**Response to Public Comments on Draft Regulatory Guide (DG)-1372
 “Design Limits, Loading Combinations, Materials, Construction and Testing of Concrete Containments”
 Proposed Revision 4 of Regulatory Guide (RG) 1.136**

On July 8, 2020, the NRC published a notice in the *Federal Register* (85 FR 41071) that Draft Regulatory Guide, DG-1372, a proposed revision of RG 1.136 was available for public comment. The Public Comment period ended on September 8, 2020. The NRC received the comments listed below. The NRC has combined the quoted comments and NRC staff responses in the following table.

Fig. 1—Stress-strain diagrams showing methods of yield strength determination.

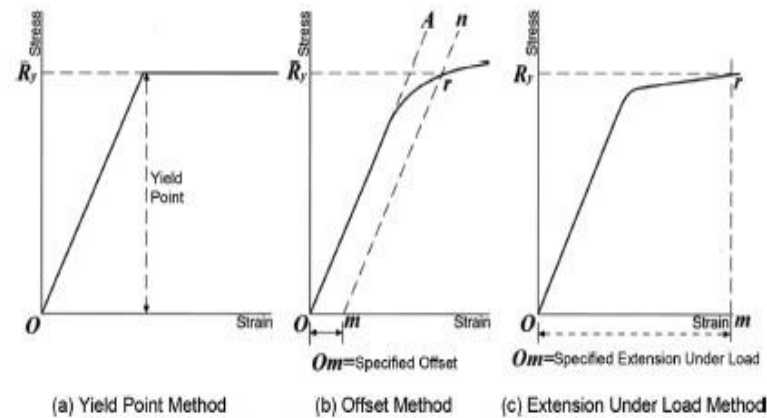
Based on testing of rebar in the industry, it is not uncommon for the measured actual yield and tensile strengths within a particular rebar heat and grade, or in each 60-foot length of rebar, to vary by as much as 5%. Determining the actual yield or tensile for qualification samples based on a single tensile test, or extracting from the CMTR in the case of production samples, will result in occasions where samples are falsely rejected or accepted simply because the determined yield strength is not truly representative of the actual length of rebar used in the mechanically spliced or headed sample. In addition, the methodology for determining the yield strength needs to be more clearly defined for steels with a “roundhouse” characteristic when a sharp yield plateau is not present.

Variation of methodology of extension under load EUL vs offset vs drop of beam methods can produce significantly different yield values. The methodology for yield determination for the steel characteristic needs strictly defined in DG-1372 to utilize the lower of the methods, because of the variation cited previously.

regulatory position 11. However, it should be noted that code paragraph CC-4333.2.3(a) requires that the average tensile strength of the splices and mechanically headed deformed bars shall not be less than 90% of the actual tensile strength of the reinforcing bar being tested; this requires determination of actual tensile strength but as alluded in the comment, the Code does not state how the actual tensile strength is to be determined. This code requirement continues to remain as-is, but the staff has clarified in the RG that actual tensile strength should be determined in accordance with testing standards, definitions and methods specified in ASTM A370.
